RE: Written Comments on the Draft EIR for Application No. 98-01-008

Calpine Corporation's
Comments on
CPUC PG&E Power Plant Sale Draft Environmental Impact Report, 8/98
Compiled by Jacob M. Rudisill and Charlene Wardlow

**FIGURE N5-1
COMPARISON OF PG&E GEYSERS GEOTHERMAL FORECASTS
(CEC Electricity Reports vs. Historic Data)**

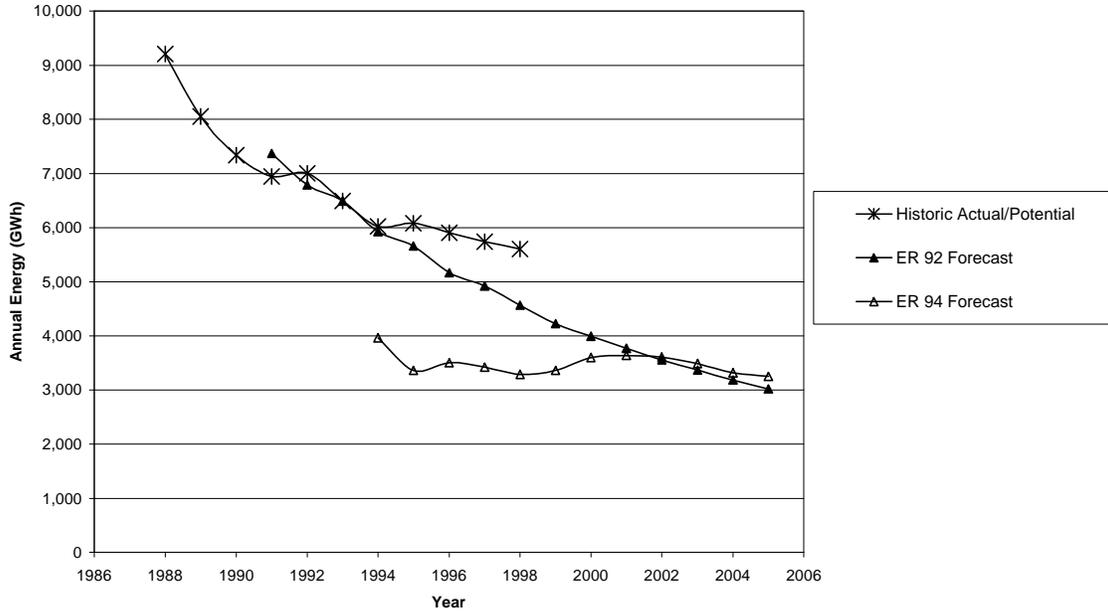
<p>2. Generation Forecast</p>	<p>Page C-9, Tables C-1, S.1, S.3, 5.2, 6.1.</p> <p>Generation from the Sonoma County units increases 4 MW from 1999 to 2005 while they operate at maximum base load output. The Lake County units decline only 8 MW.</p>	<p>[Begin N5] This claim that the field will undergo a dramatic reversal of its historic performance trends is unsupported by any assumption in the document. PG&E’s estimates of hypothetical available generation in years of heavy curtailment appear to have been extrapolated without regard for the actual operating conditions of the forecast period.</p>

The 1992 and 1994 CEC Electricity Report forecasts for Geysers generation were found by analysis to be outdated. Figure N5-1 compares historic actual or available (when curtailed) generation through 1998. It is immediately obvious that the Geysers steam resource is not declining as rapidly as forecast in 1992 and 1994. PG&E’s *Report on Reasonableness of Operations for 1997* discusses the many reasons for this dramatic change in the decline. For this reason, a new forecast was developed.
